**STAFF REPORT**  
**COMMUNITY DEVELOPMENT DEPARTMENT**

HEARING DATE: September 16, 2021  
 TO: Planning & Zoning Commission  
 FROM: Joseph Dodson, Associate Planner  
 208-884-5533  
 SUBJECT: H-2021-0049  
 Fairview Row Townhomes CUP  
 LOCATION: The site is located at 2065 E. Fairview Avenue, in the NE ¼ of the NW ¼ of Section 8, Township 3N., Range 1E.

Conditional Use Permit for a multi-family development consisting of 16 attached townhome units on 1.02-acres of land in the C-G zoning district, by Riley Planning Services.

EXTERIOR ELEVATIONS

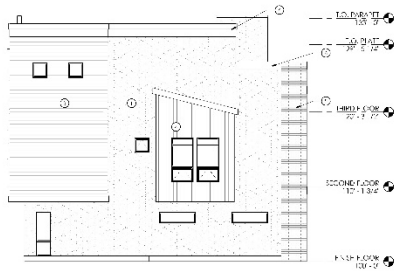
*Initial review of the conceptual building elevations shows 3-story buildings that combine different field materials, modulation, and material coloring. The main materials shown are stucco, lap siding, and stone cladding. The elevations also show second and third story decks that offer both recreation and a different architectural element to the elevations. Preliminary review of the elevations show compliance with the Architectural Standards Manual but Staff will confirm compliance with the future Design Review application.*

OVERALL PLANS

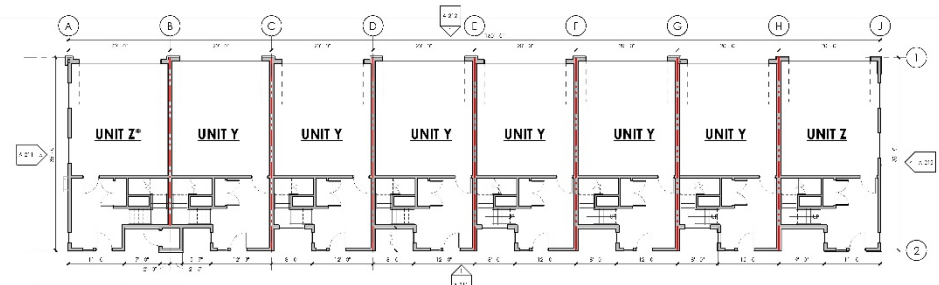
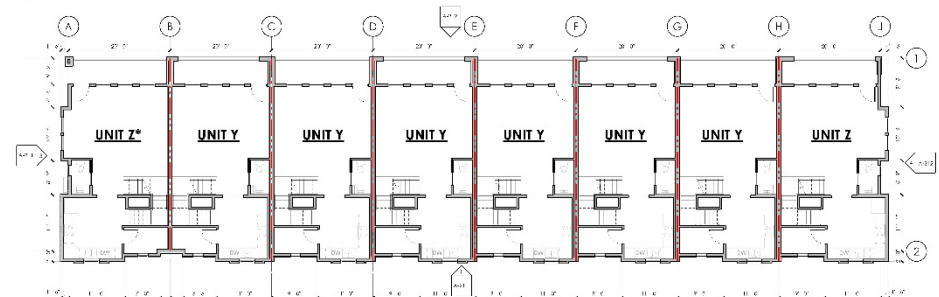
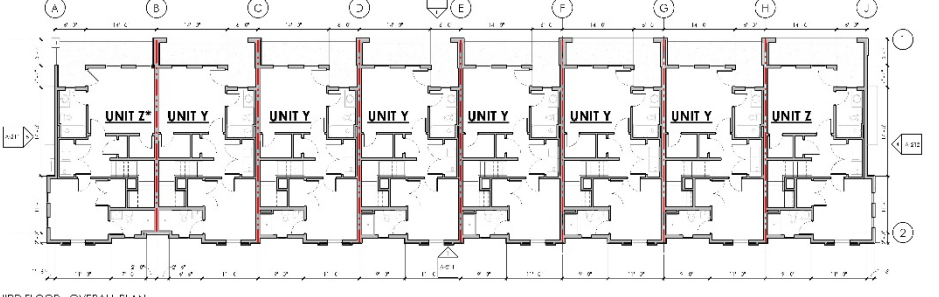
***Based on the number of bedrooms per unit (16 two-bedroom units), a minimum of 32 parking spaces should be provided with at least half of those spaces covered or within a garage. The Applicant has proposed a total of 35 parking spaces with each unit having a tuck-under two-car garage and three (3) surface parking spaces intended for guest parking. Therefore, the proposed parking is in excess of code requirements for total number of spaces and the number of covered spaces required. It should be noted that Wilson Lane is a commercial collector and posted with no parking signs, so guest parking will be limited in this development.***

5. Future development shall be consistent with the minimum dimensional standards listed in UDC Table 11-2B-3 for the C-G zoning district.
6. Off-street parking is required to be provided in accord with the standards listed in UDC Table 11-3C-6 for multi-family dwellings based on the number of bedrooms per unit.
